**Response to NRC Review Comments  
Transmitted by Letter Dated June 22, 2001,  
to the Nuclear Energy Institute Relating to**

***PWR Materials Reliability Program  
Interim Alloy 600 Safety Assessment for US PWR Plants (MRP-44)  
Part 2: Reactor Vessel Top Head Penetrations  
EPRI TP-1001491, Part 2, May 2001***

**MRP 2001-050NP**

**June 29, 2001**

Figure 1  
Locations of Leaking CRDM Nozzles at Oconee and ANO-1

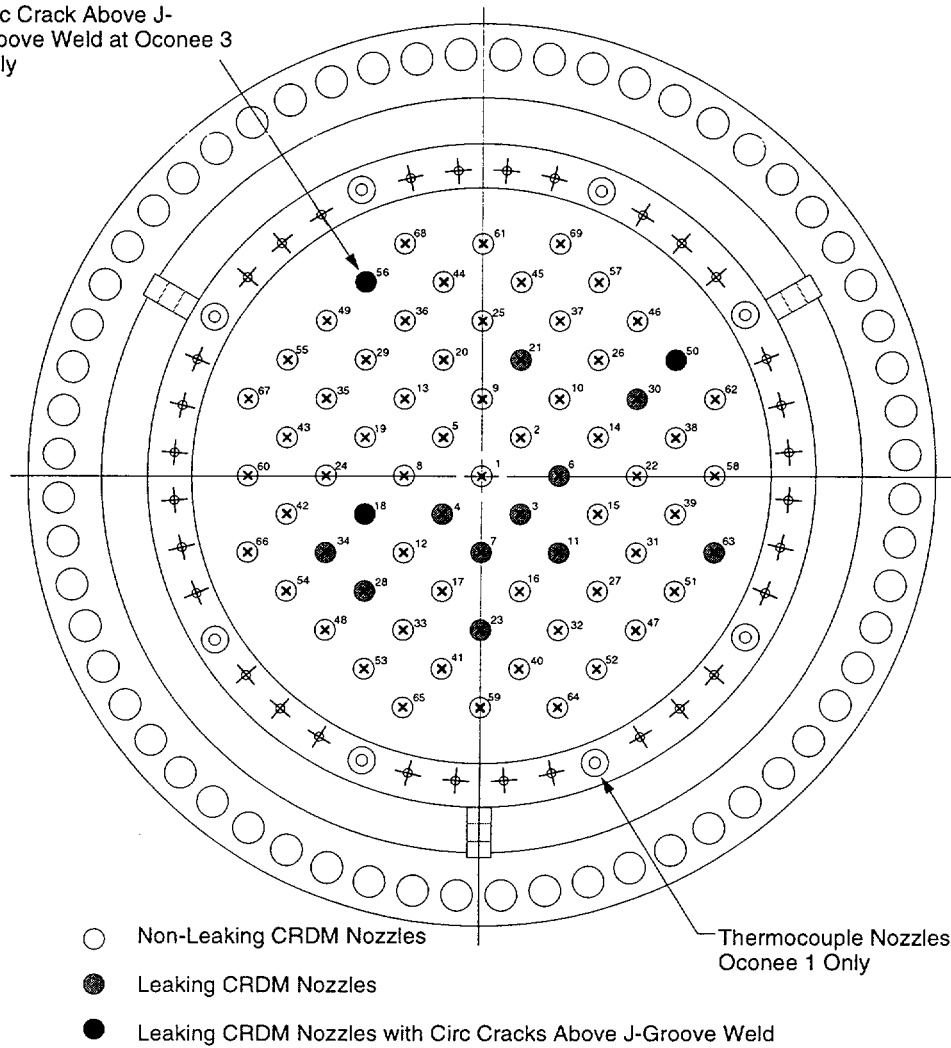
*"Appropriate consideration of the interference fit incorporated into the initial fabrication of the vessel head penetrations (VHPs) is important in evaluating the ability of visual leakage detection methods (e.g., boric acid walkdowns) to accurately identify through-wall degradation at the subject locations. While the recent instances of cracking in several VHPs at ANO-1 and Oconee Units 2 and 3 indicate that it is possible to detect through-wall flaws caused by primary water stress corrosion (PWSCC) based on boric acid walkdowns that can look under the insulation, the information provided in Section 3 of the MRP-44, Part 2 report does not support the conclusion that these events were "bounding" (i.e., that, for a similar size through-wall flaw at some other facility, an equivalent or greater amount of leakage would be expected)."*

- As shown in Figure 1, Oconee and ANO-1 experience demonstrates that leakage can be detected from nozzles adjacent to the central nozzle and in peripheral locations. This provides confidence that leakage can be detected regardless of location on the head.

Figure 3  
Actual Interference Fits of Leaking CRDM Nozzles at Oconee 1, 2 and 3 and ANO-1

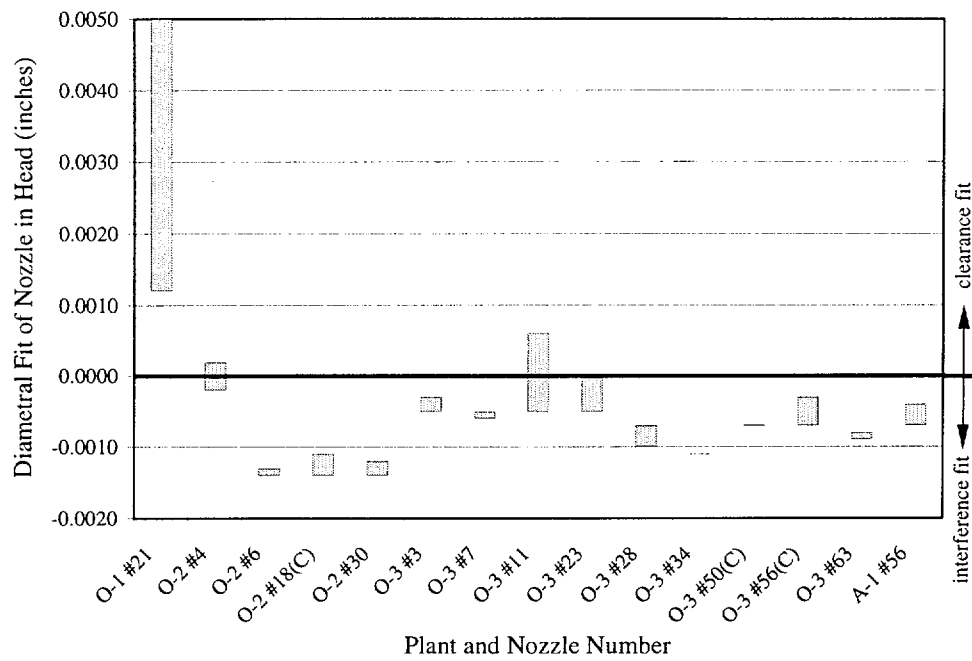
*"In order to better understand the leakage potential of PWSCC at VHP locations, and to assist in understanding how comparisons can be made to the leakage potential for VHPs at other facilities, the staff request additional information detailing the precise interference fits (as opposed to a range of values) for the VHPs which leaked at ANO-1 and Oconee."*

Figure 3 shows the range of fits for the leaking CRDM nozzles at Oconee and ANO-1. The information provided during the June 7 meeting for Oconee 1, Oconee 3 and ANO-1 has been supplemented with data for the four leaking nozzles at Oconee 2. The three nozzles found to have circumferential cracks above the J-groove weld are appended with "(C)" in the figure.

The data in Figure 3 show that one nozzle had a clearance fit rather than the specified small interference fit. The remaining nozzles had at least one end of the interference fit region within the specified tolerance. It should be noted that three of the four leaking nozzles at Oconee 2 had interference fits of 0.0014 inches at one end and at least 0.0011 inches at the other end. In summary, leaks have been confirmed from fourteen nozzles with confirmed initial interference fits, including three nozzles with at least 0.0014 inches of assembly interference.

Figure 4  
Typical FEA Model of Central CRDM Nozzle

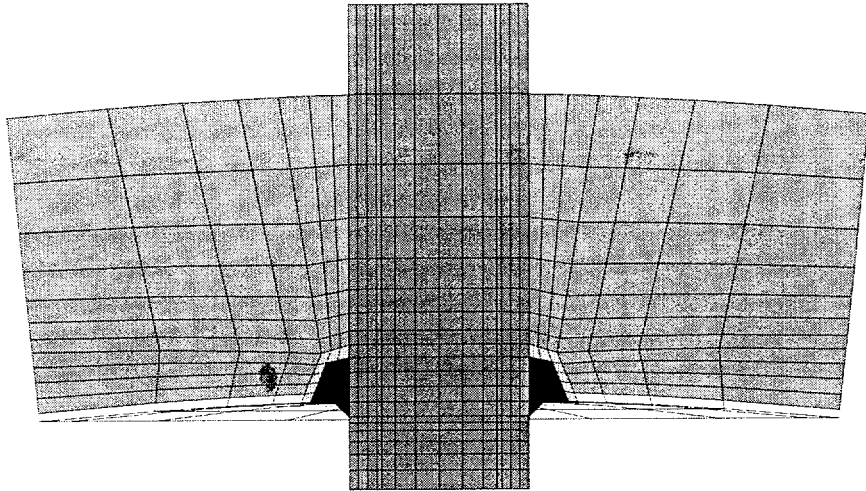
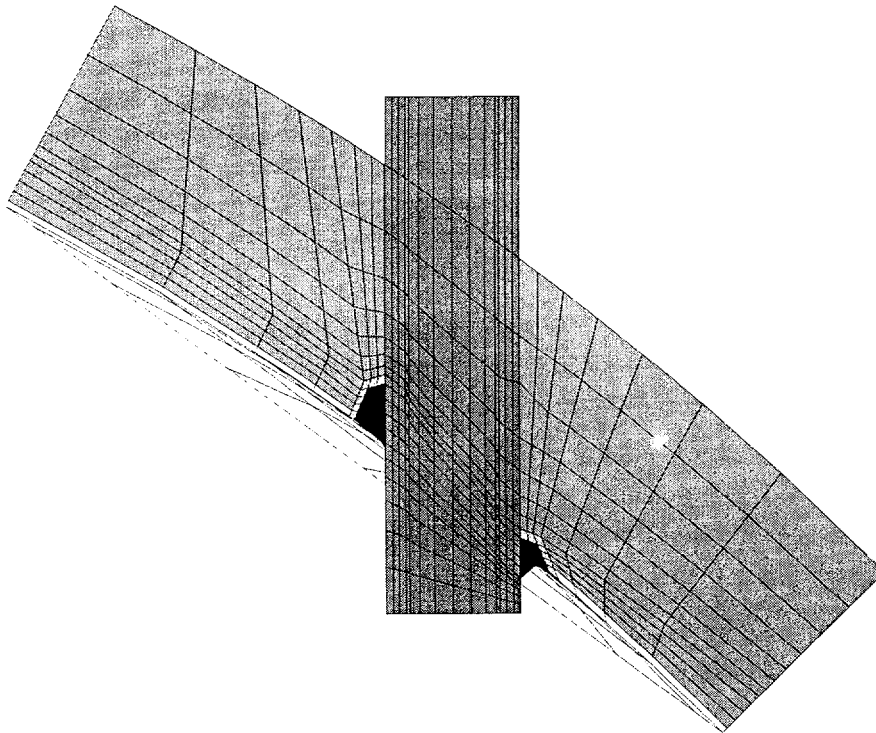
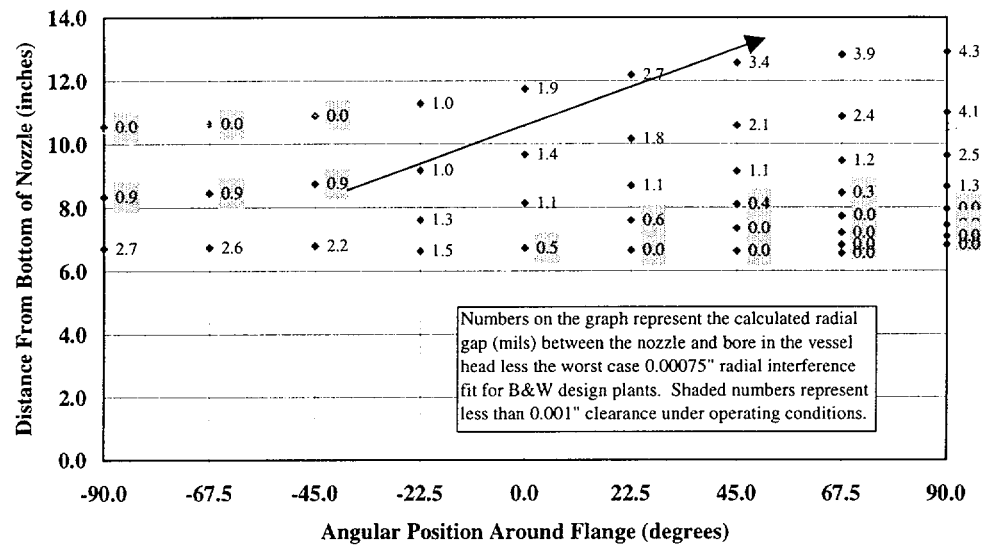
*"The staff notes that, based on information in ASME Code Section II, Part D, the coefficient of thermal expansion for Alloy 600 is slightly greater than that for low alloy vessel steels throughout the temperature range of interest (70 °F to 600 °F). This would lead to the conclusion that the magnitude of the interference fit would grow as the vessel was heated up from room temperature to operating temperature. Further, internal pressurization of the VHP nozzle may be expected to further expand the nozzle into the vessel head penetration. Other potential effects related to RPV head distortion at pressure, flange rotation, and/or vessel head penetration ovalization are not discussed in Section 3.0. Address how these factors may affect central and peripheral VHPs differently. Provide additional information to support your statement that "...analyses show that the initial fit tends to open up at operating temperature and pressure." Provide details on the finite element analysis (FEA) of the RPV head used to support this statement, including modeling assumptions, boundary conditions and results."*

Second order effects such as deflection and ovalization of oblique nozzles under pressure loading are assessed by finite element modeling of the nozzle and vessel head. Each of the NSSS vendors and EPRI has models of reactor vessel top head nozzles. Figures 4 and 5 show typical models of central and peripheral row CRDM nozzles and the associated J-groove welds. The models shown include the nozzle, a sector of the vessel shell, J-groove weld, J-groove weld buttering, and vessel cladding. Boundary conditions are imposed on the sector of the vessel shell to simulate the nozzle being installed in a complete spherical shell, and to model the initial

Finite element analyses show that oblique CRDM nozzles displace laterally if a clearance opens up between the nozzle and bore under operating conditions. The resultant displacement reduces the leak path at some locations and increases the leak path at other locations. Typical analysis results for a peripheral CRDM nozzle are shown in Figure 6. The net effect shown in this figure is to open up a spiral leak path which has less flow resistance than a uniform annular gap.

Finite element analyses of a model including the nozzle, vessel shell, and flange show that flange tensioning and resultant rotation increase the ovality of peripheral row CRDM nozzles by approximately 20%. This effect is small and, as noted in the previous paragraph, should decrease the flow resistance.

The effect of ovalization in oblique nozzles and flange rotation are primarily to change the shape of the leak path from annular to a spiral leak path. This has the beneficial effect of decreasing the flow resistance.

Figure 7  
Visual Inspection of Oconee 3 Reactor Vessel Head (Leaking Nozzle 56)

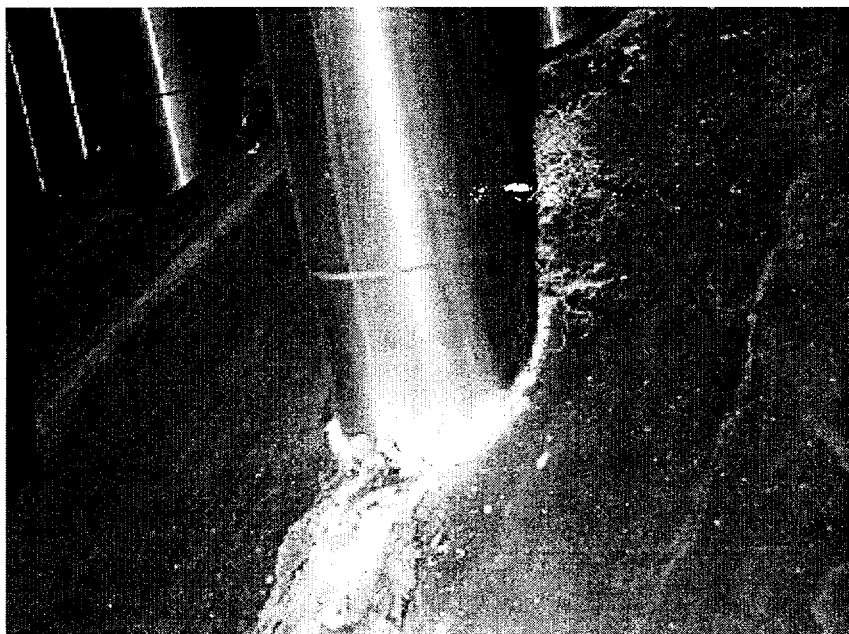
*"At a public meeting on June 7, 2001, at NRC headquarters, the industry representatives described visual examinations conducted under the insulation at several PWRs. Provide any photographic documentation that can serve to demonstrate the expected conditions, accessibility and inspectability of the RPV head for such arrangements."*

- Figure 7 is Oconee 3, where visual inspection was performed through access ports that had previously been cut in the shroud. Leakage is clearly visible in the photograph.

Figure 15  
Stress Analyses of Peripheral CRDM nozzle in Intact (a) and Cracked (b) Configurations

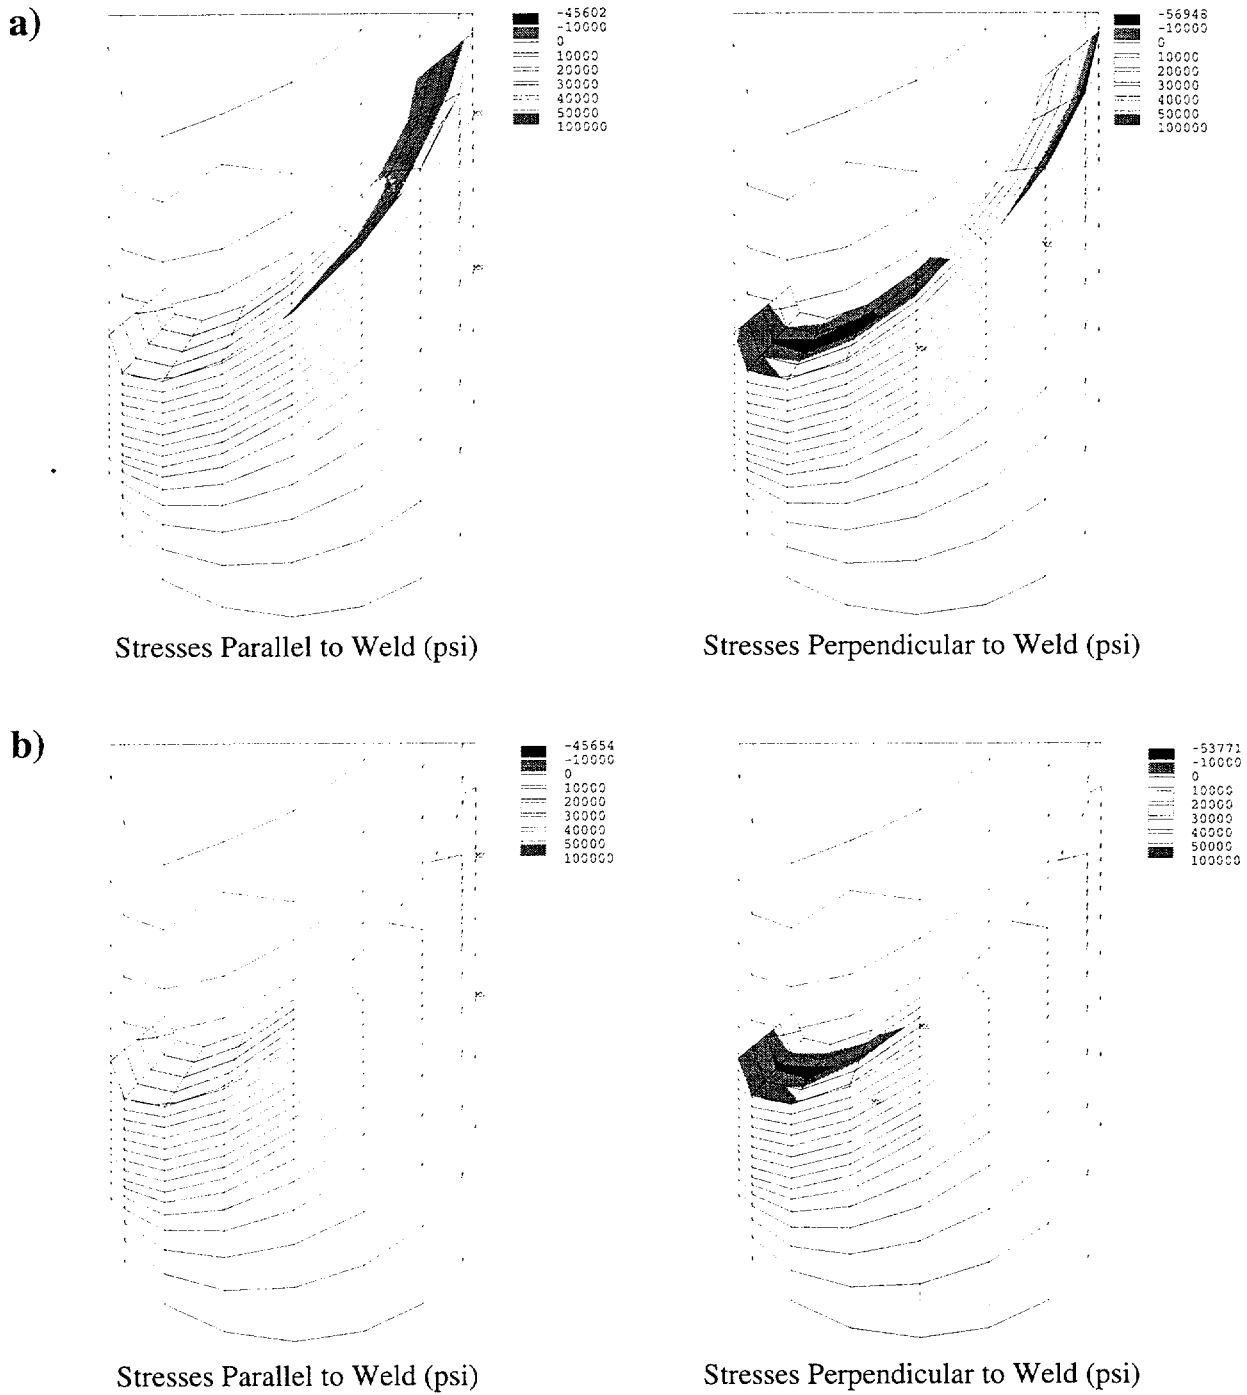
*"At a public meeting on June 7, 2001, at NRC headquarters, the industry representatives described finite element analyses (FEA) for circumferential cracks in peripheral CRDM nozzles. Provide details of the FEA modeling assumptions (such as symmetry, boundary conditions and residual stresses), the resultant stresses, and the applied stress intensity factors. How do these parameters change (e.g., stress redistribution) with crack growth in the nozzles?"*

Finite element models of CRDM nozzles have been developed by each of the NSSS vendors and EPRI. Typical models are described under the response to Section 3.0 Comment 3 and in previous submittals to the NRC in 1993-94. Typical models for central and peripheral row nozzles shown in Figures 4 and 5 have 180° symmetry and boundary conditions imposed on the sectors of the head shell to simulate an infinite shell. The J-groove welds in these models were simulated by combined thermal and structural analyses. A transient thermal analysis was used to generate nodal temperature distributions throughout the welding process. These nodal temperatures were then used as inputs to structural analyses which calculated resultant thermally-induced residual stresses as the welds cooled and gained strength. The sequence of thermal analysis followed by structural analysis was duplicated for each simulated weld pass.

Analysis results were presented at the June 7 meeting showing stresses parallel to and perpendicular to the J-groove weld for a peripheral nozzle in the intact operating condition, including the effects of welding residual stresses and hydrostatic testing prior to operation, and with the weld cracked 180° around on the uphill side of the nozzle at the elevation of the weld root. These results are repeated in Figure 15, which also shows the values for the stress contours. These data show that stresses are significantly reduced after cracking has removed some of the constraint that caused high welding residual stresses.

The model shown in Figures 4, 5 and 15 was not used to calculate crack tip stress intensity factors directly. Stress intensity factor calculations are currently being sponsored by the MRP using the finite element analysis results as inputs. Until such time as the finite element based stress intensity calculations are completed, calculations of crack growth have been performed using more traditional models such as described under Section 5.0 Comment 1.
